Subject: Virgil C. Summer Nuclear Station
Docket No. 50/395
Operating License No. NPF-12
Response to Generic Issues From
NRC Bulletins 79-02/79-14 Follow-Up
Inspection Report 50-395/89-200

1.0 ZERO PERIOD ACCELERATION (ZPA) - RESPONSE TO NRC INSPECTION REPORT 50-395/89-200, APPENDIX C, ITEM 1

2.0 SEISMIC ANCHOR MOVEMENT (SAM) ADJACENT STRUCTURE ISSUES - RESPONSE TO NRC INSPECTION REPORT 50-395/89-200, APPENDIX C, ITEMS 2a, AND 2b

3.0 CONTAINMENT GROWTH ISSUES - RESPONSE TO NRC INSPECTION REPORT 50-395/89-200, APPENDIX C, ITEM 3

DISPLACEMENTS UNDER STEADY STATE THERMAL LOADS

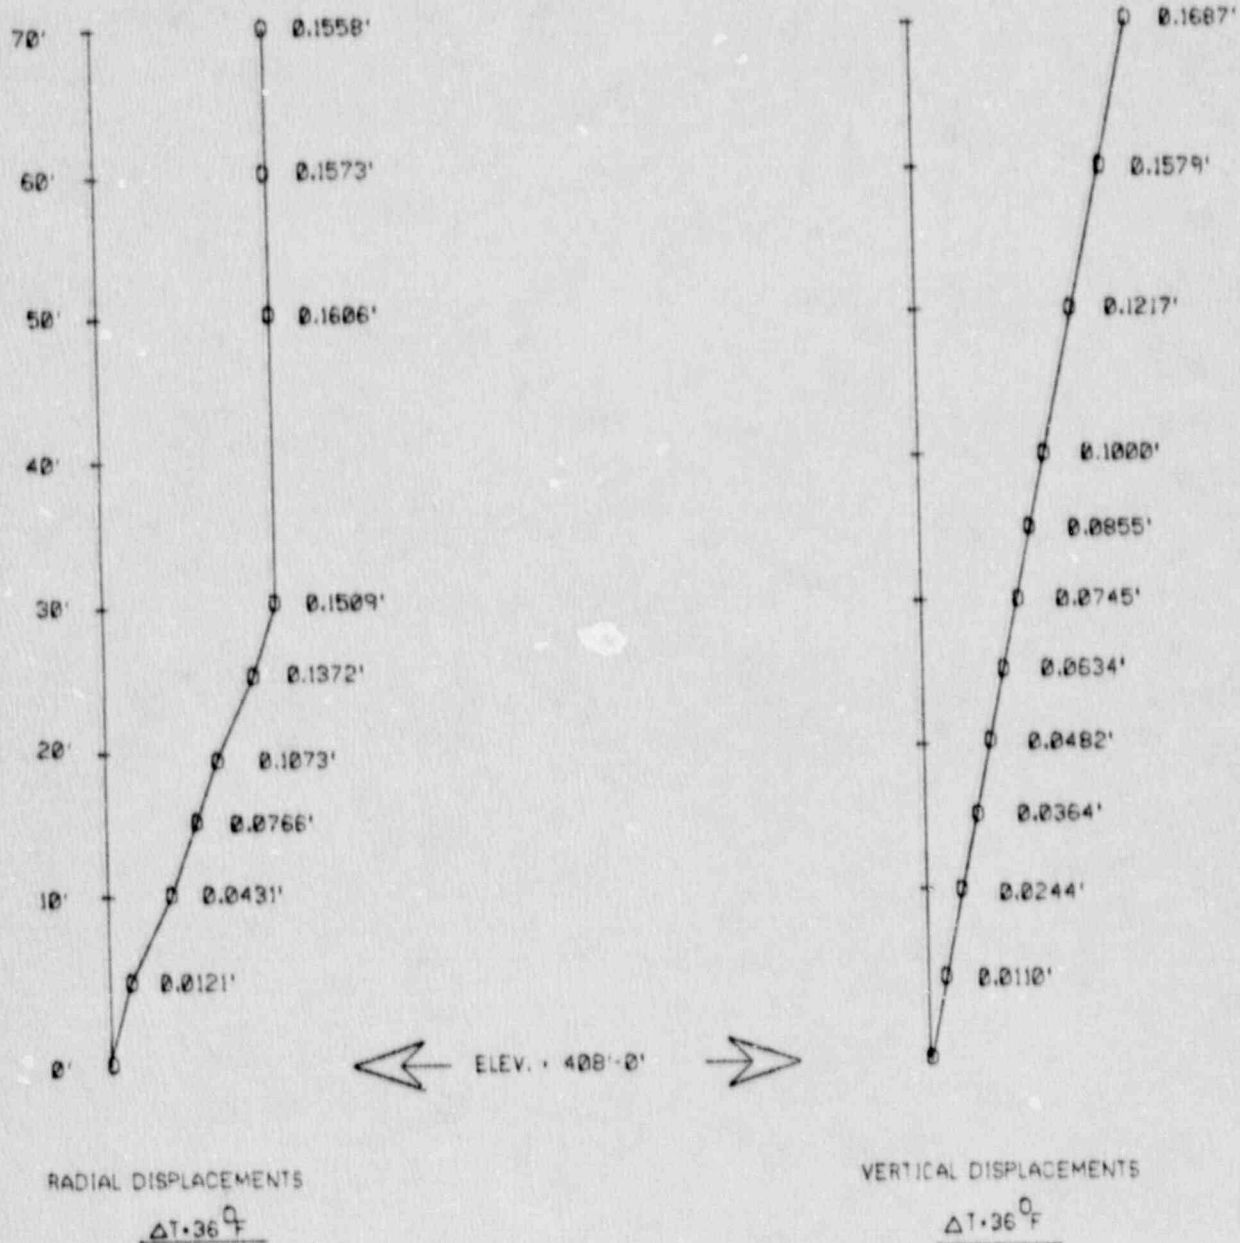
Calculations were performed to predict the maximum thermal growth of the Containment Building under winter and summer start-up and shut-down conditions (Ref 18). The basis for the calculations is the thermal gradients presented in the FSAR (Ref. 4), Figure 3.8-23.

Two methods were used in performing the calculations. The first method involved a hand calculation approach using classical elastic equations developed by Hetenyi (Ref. 9). The second approach involves the ratioing of results from the original Kalnins (Ref. 10) shell analysis. Correlation of the two results was close, and the values to be used in the evaluation of

piping attached to containment are summarized in Attachment III, Appendix A.

FIGURE 4
Displaced Wall Configuration
at 30 PSIG

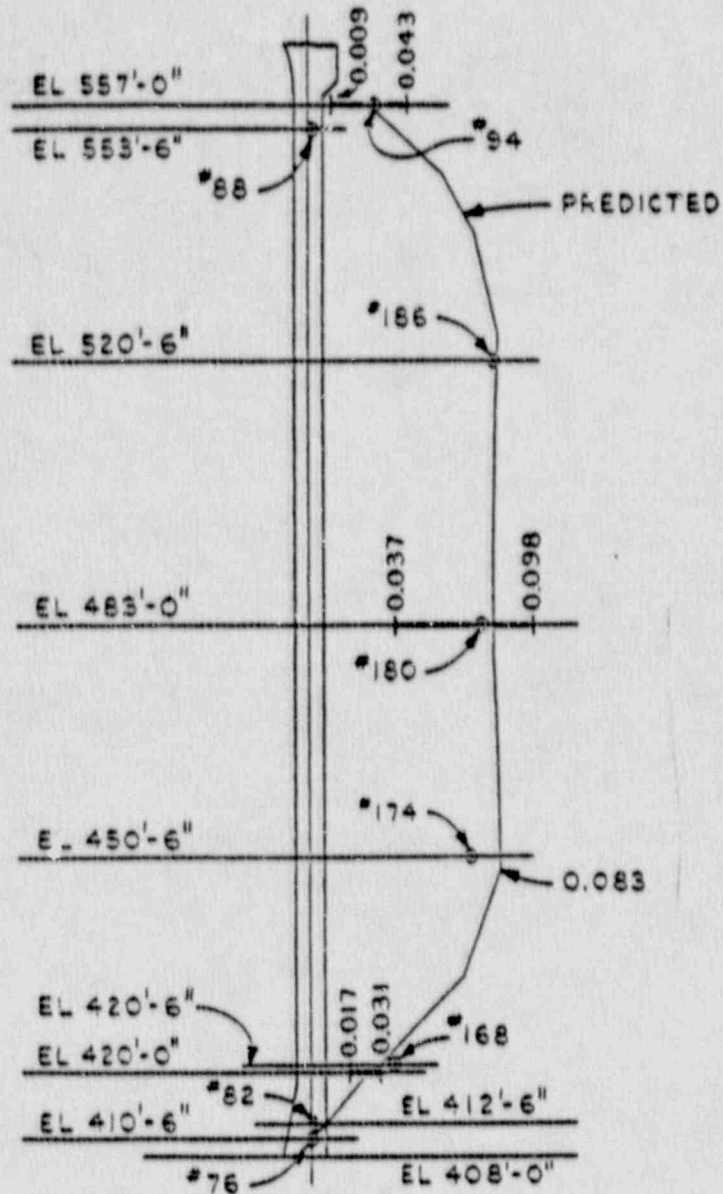
The growth of containment due to LOCA pressure is based on results from the structural acceptance test. These results for both 30 psi and 65.6 psi are presented in Attachment III, Appendix B. Movements for a LOCA pressure were obtained by ratioing results from the Structural Acceptance Test (SAT) based on the maximum pressure for a LOCA (46 psi).

The maximum measured displacements for the SAT were 0.213 inch radial (@ Az 162°30', mid-cylinder) and 0.197 inch vertical at the ring girder (say 0.10 inch at mid-height). A review of the penetration layout drawings shows there are no penetrations within 40 feet of this location. The largest radial movement at a penetration is 0.18 inch. Using the 0.18 inch value for radial growth and 0.10 inch for vertical growth, the estimated radial and vertical displacements for a LOCA, are computed as follows:

$$\frac{46}{65.6} (0.18 \text{ inch}) = 0.126 \text{ inch radial}$$

$$\frac{46}{65.6} (0.10 \text{ inch}) = 0.07 \text{ inch vertical}$$

The larger of these displacements, which is in the radial direction, is approximately 1/8 inch.
